UK Healthcare Richmond Improvements

ADDENDUM # 3

Addendum #03

Client	University of Kentucky Healthcare	Date	2025-03-21
Project	UK Richmon MOB	UK Project #	12566, 12567, 12568, 12569
	UK - CCK-1256x-1-25	Champlin Project #	514-7484

3 INTERIOR ELEVATION - CHECK-IN/OUT REGISTRATION 101 - WEST 1
A401 3/8" = 1'-0"

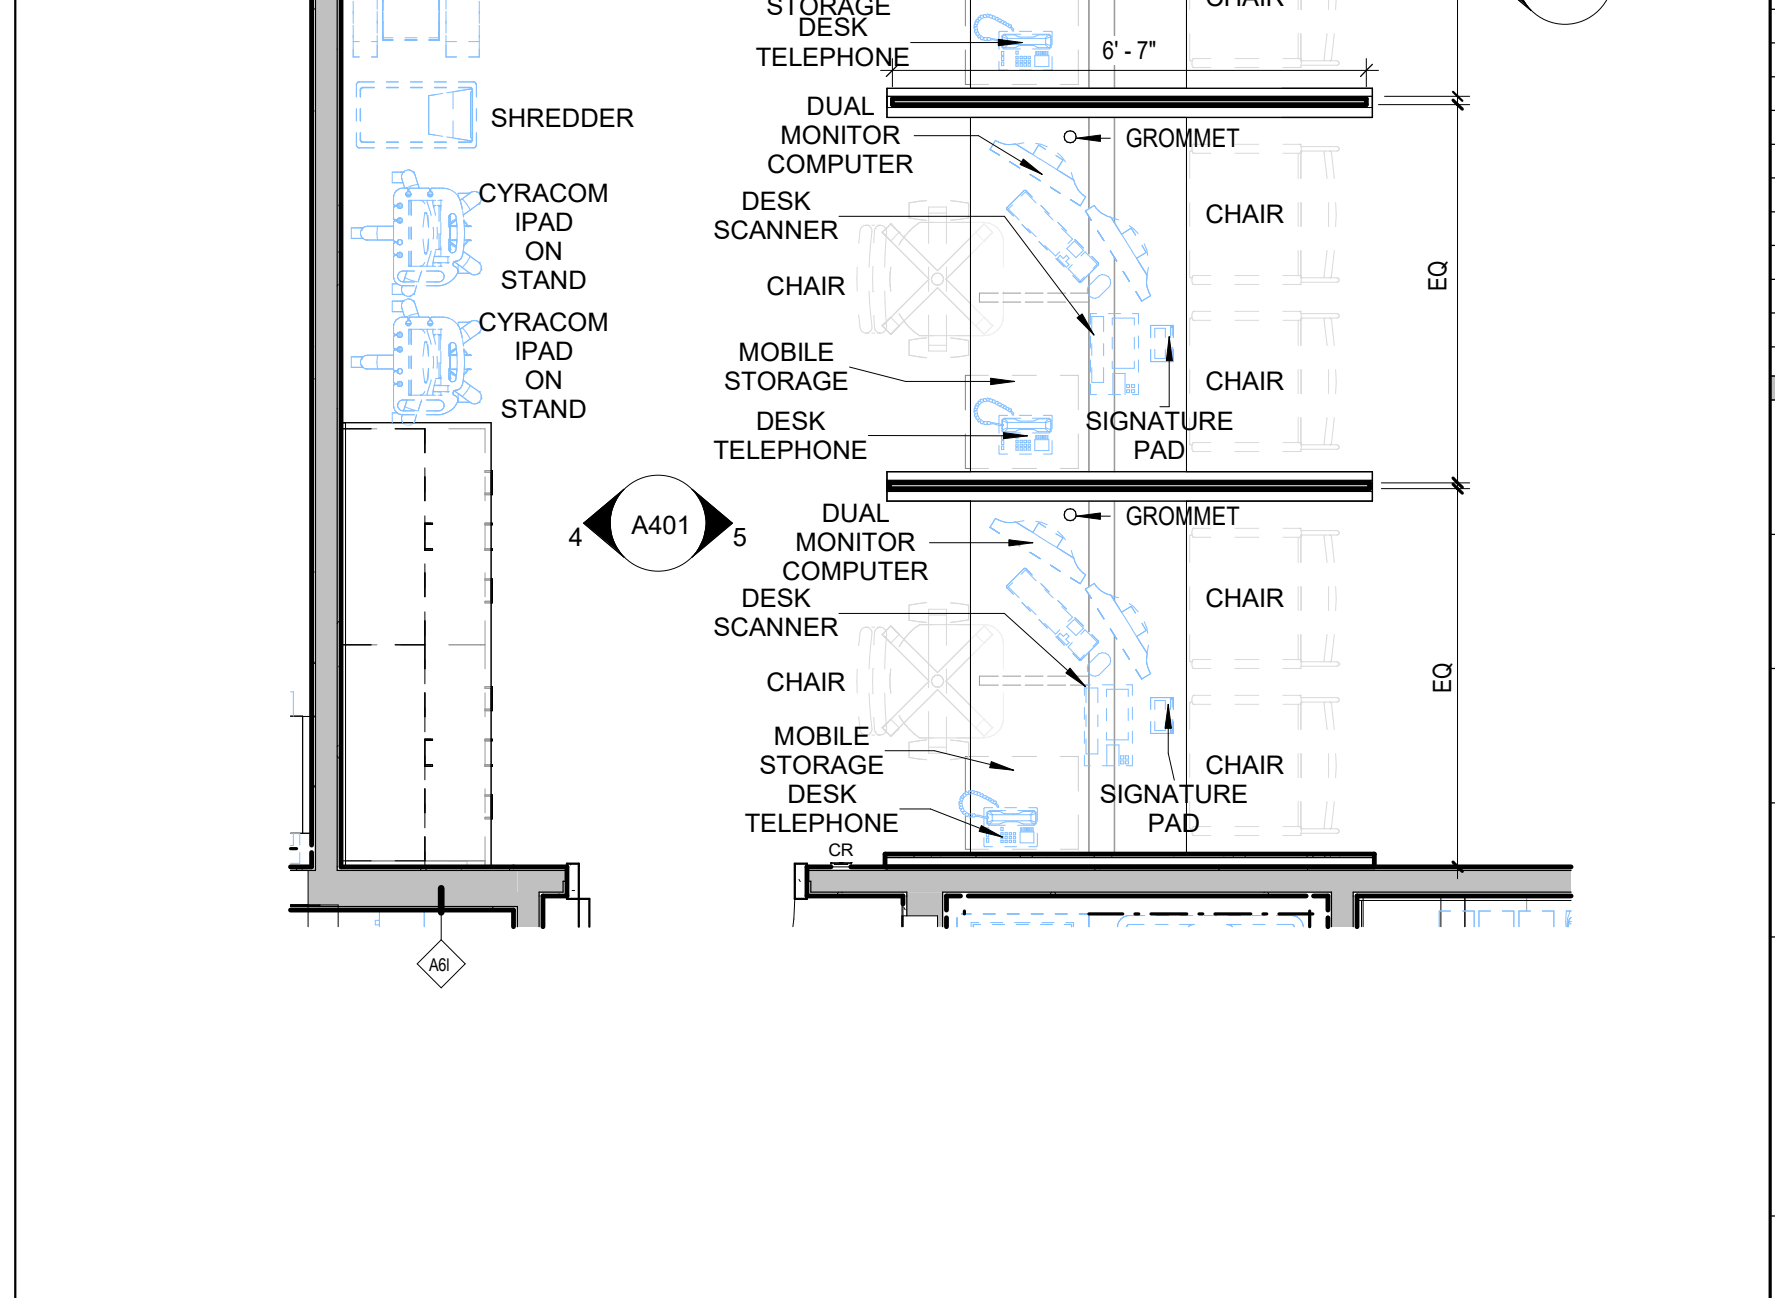
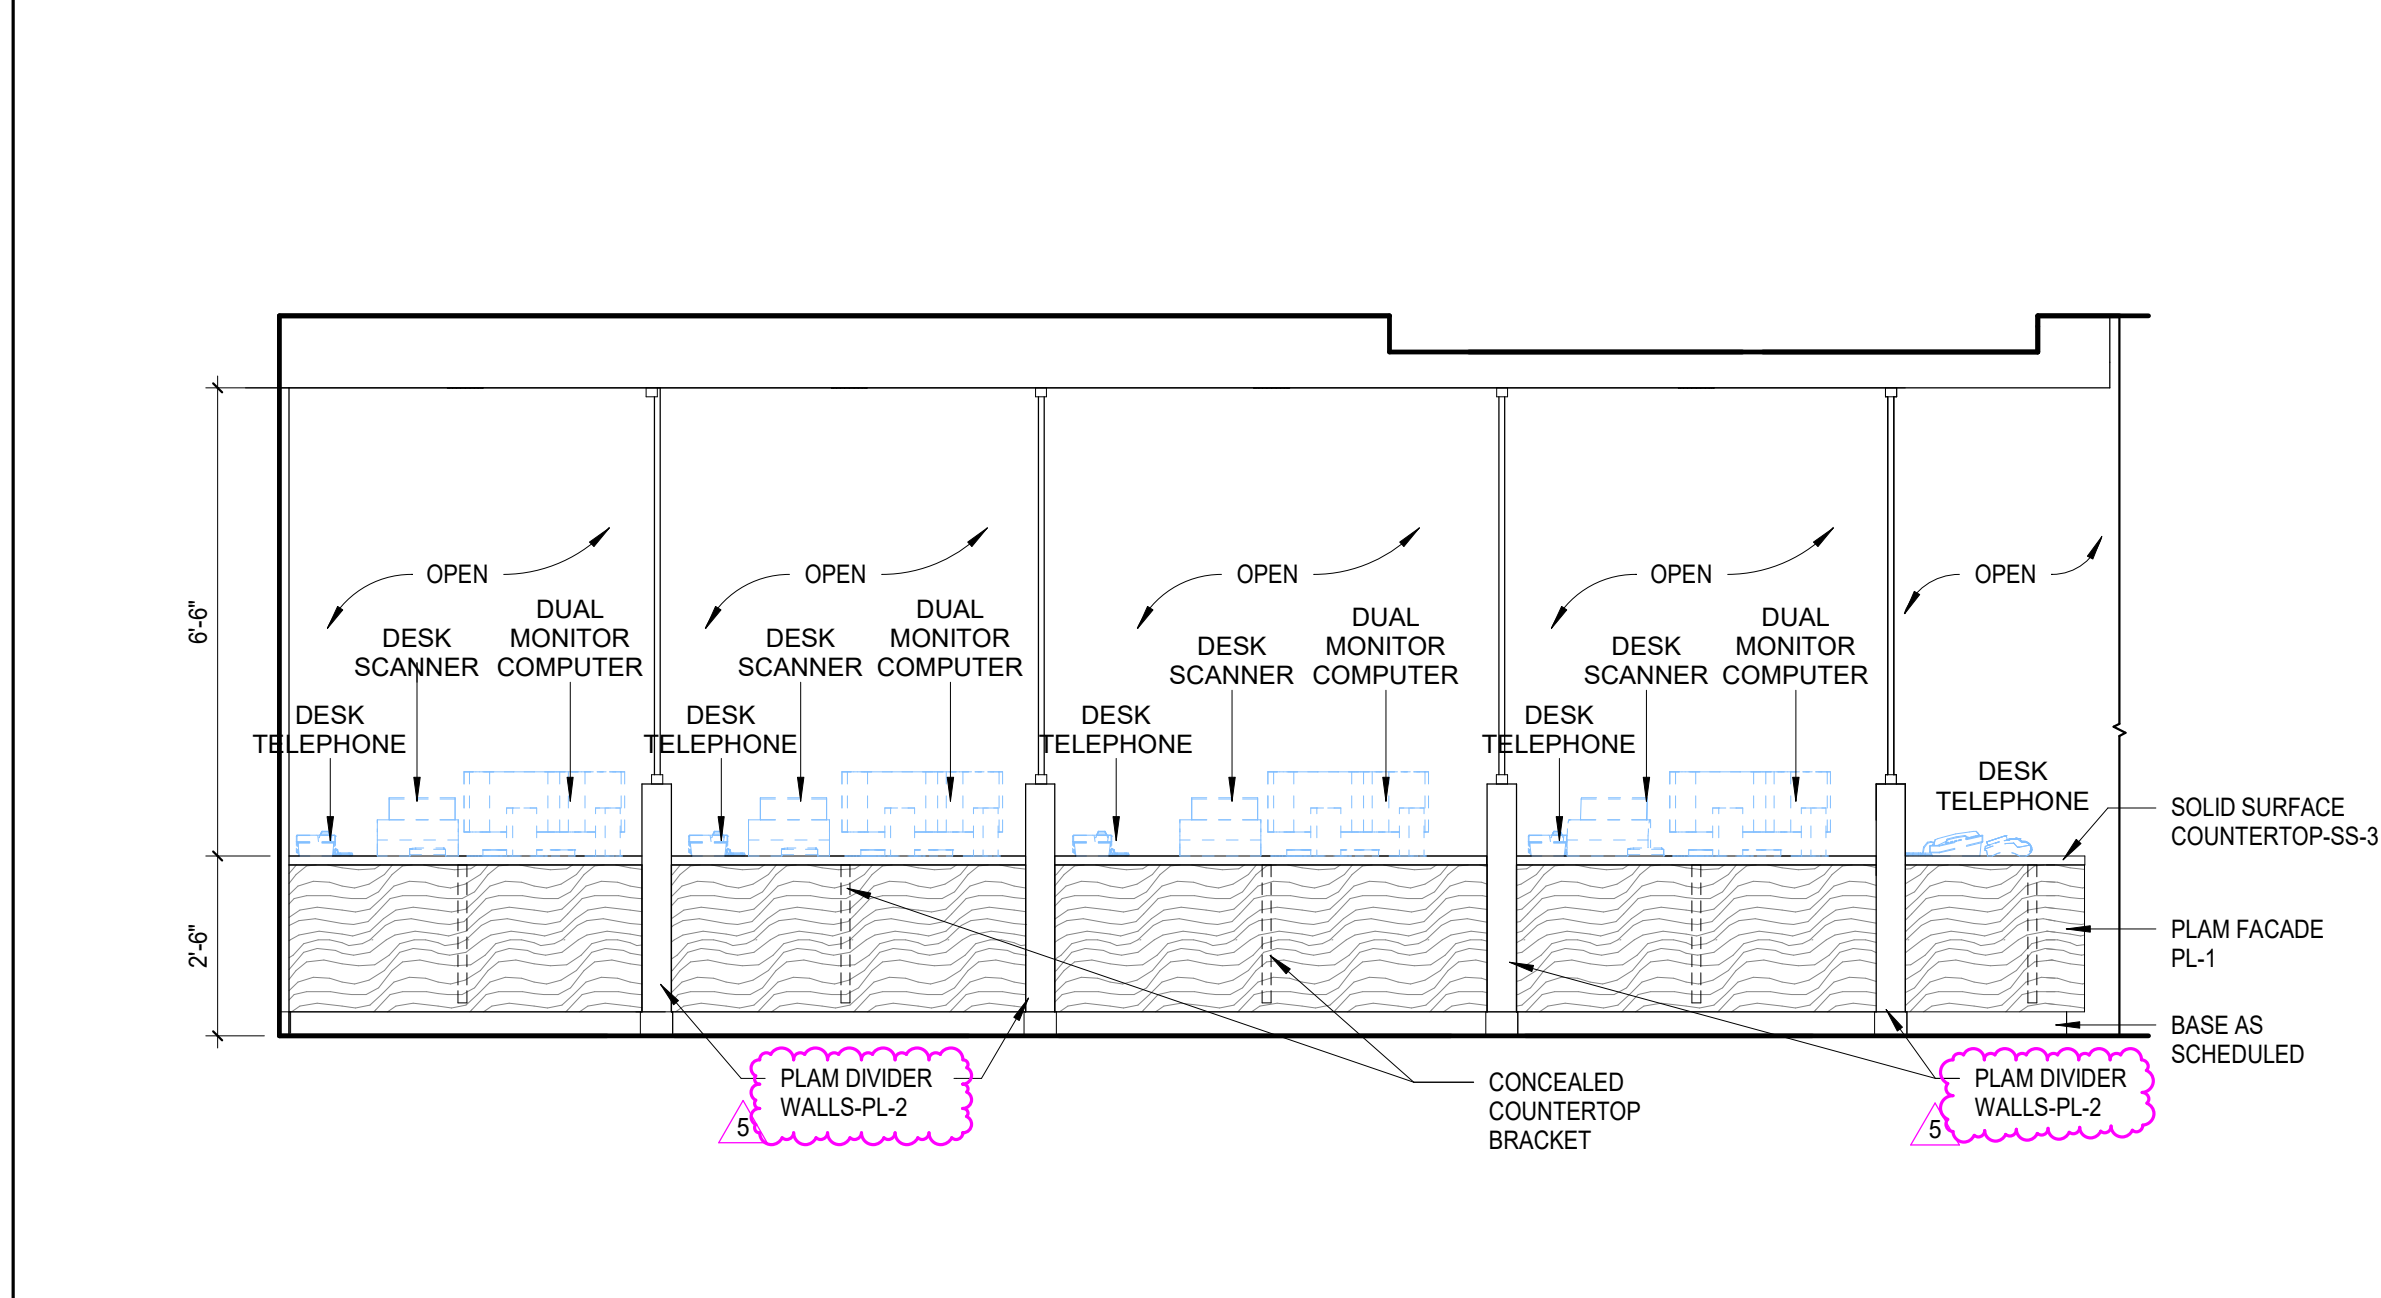
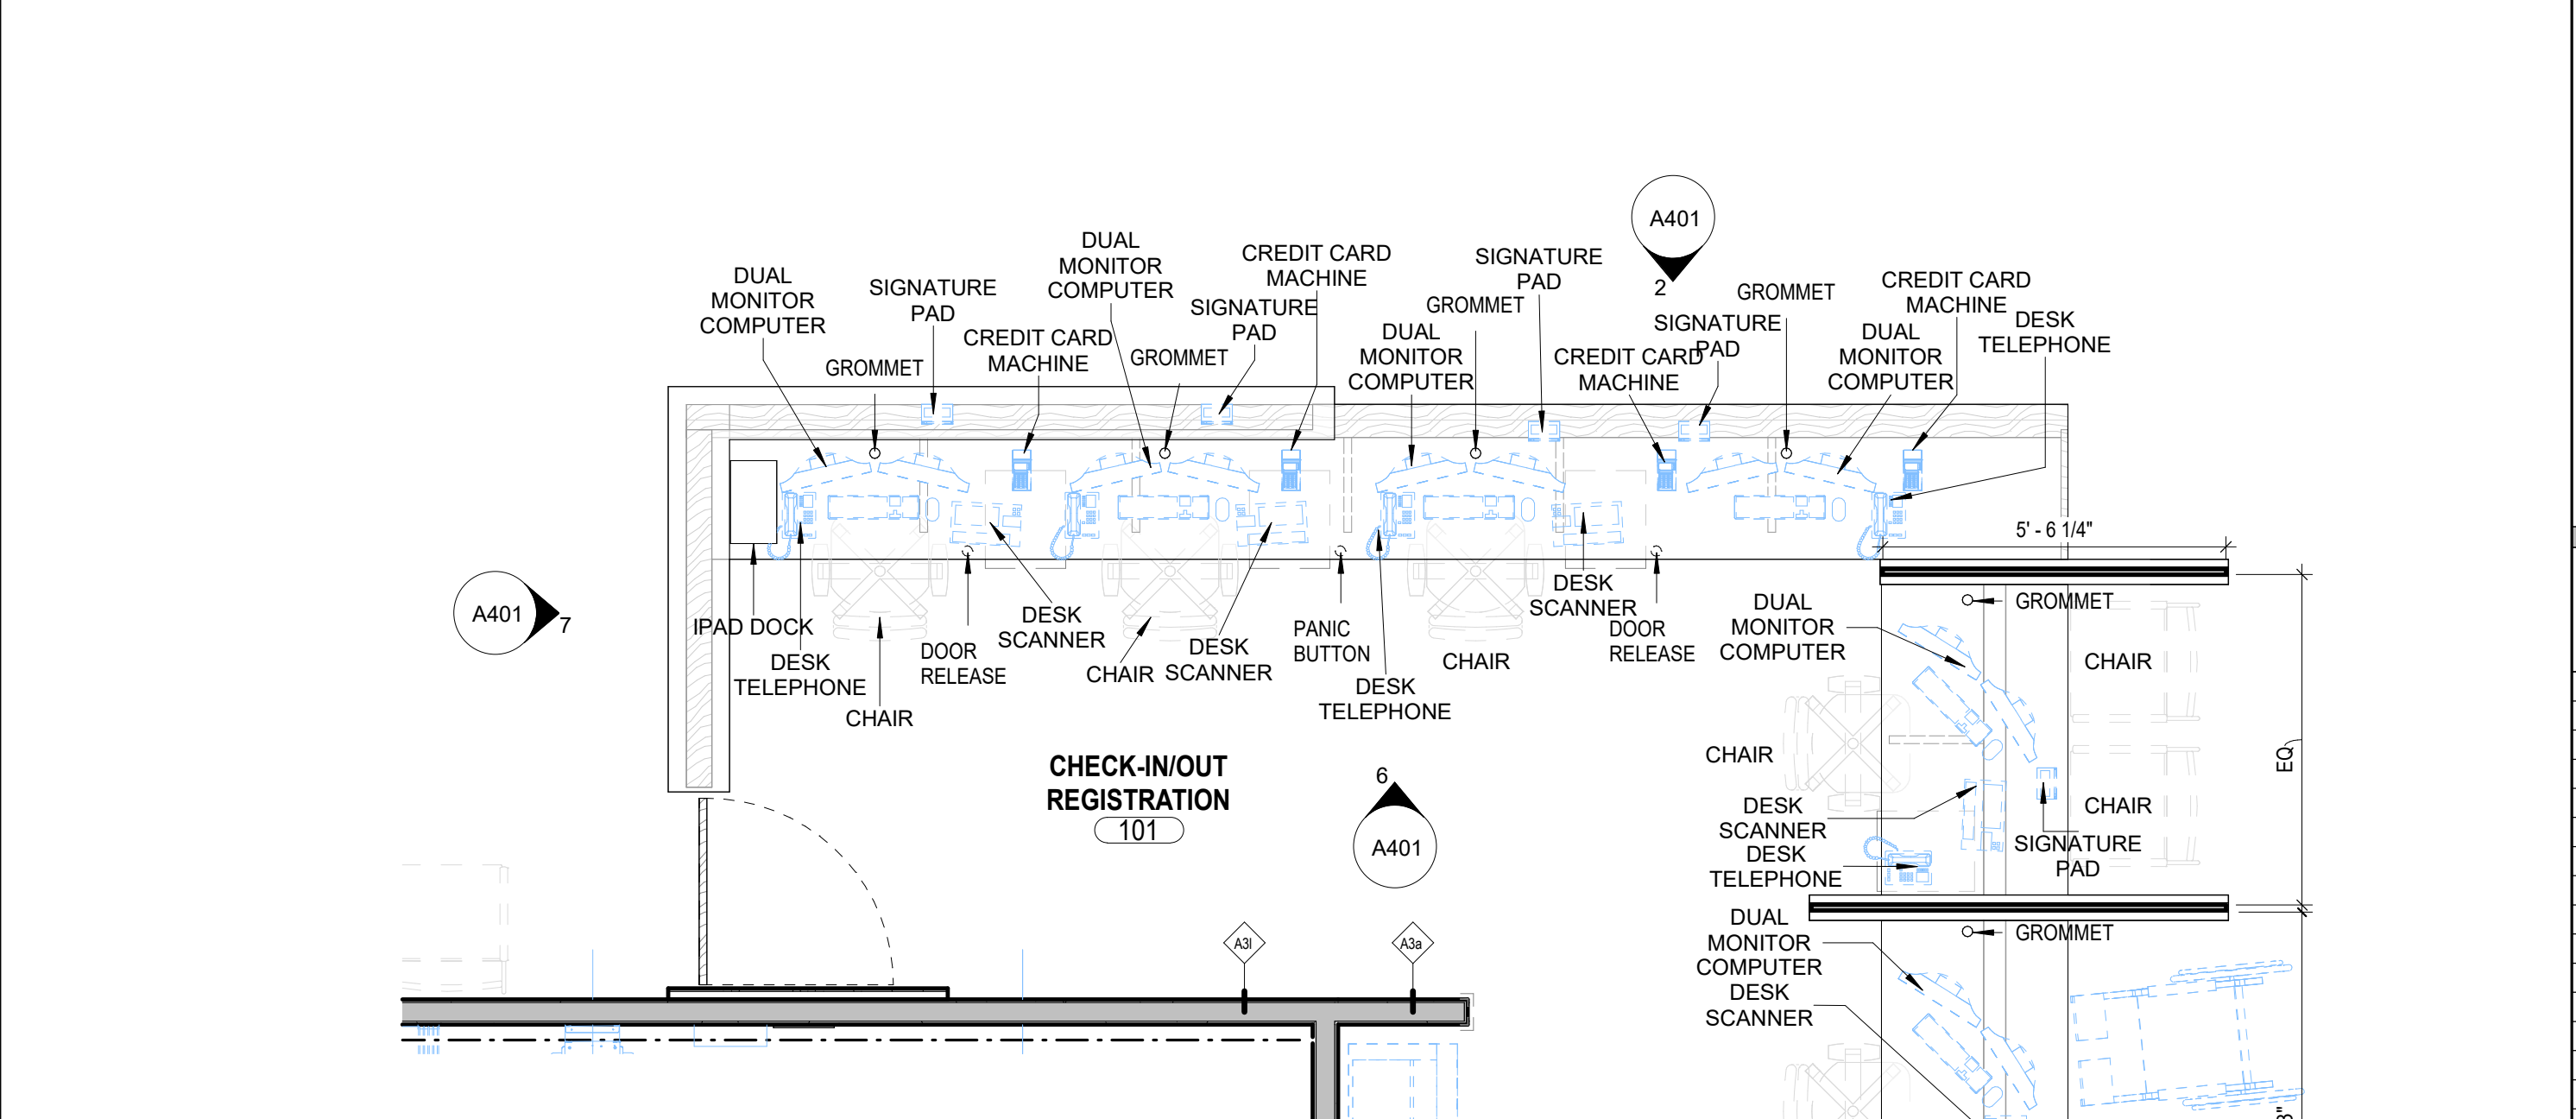
1. Clarify location of PL-2 on interior elevations 3 & 5.

- i. PL-2 is ONLY at the divider walls in the Check-In / Out desk at Registration 101 and the open shelf ONLY at detail 6/A802. This is the only location for PL-2 and is clarified on elevations 3 & 5/A401, & noted in detail 4/A802. Sheet A401 has been reissued with this addendum.
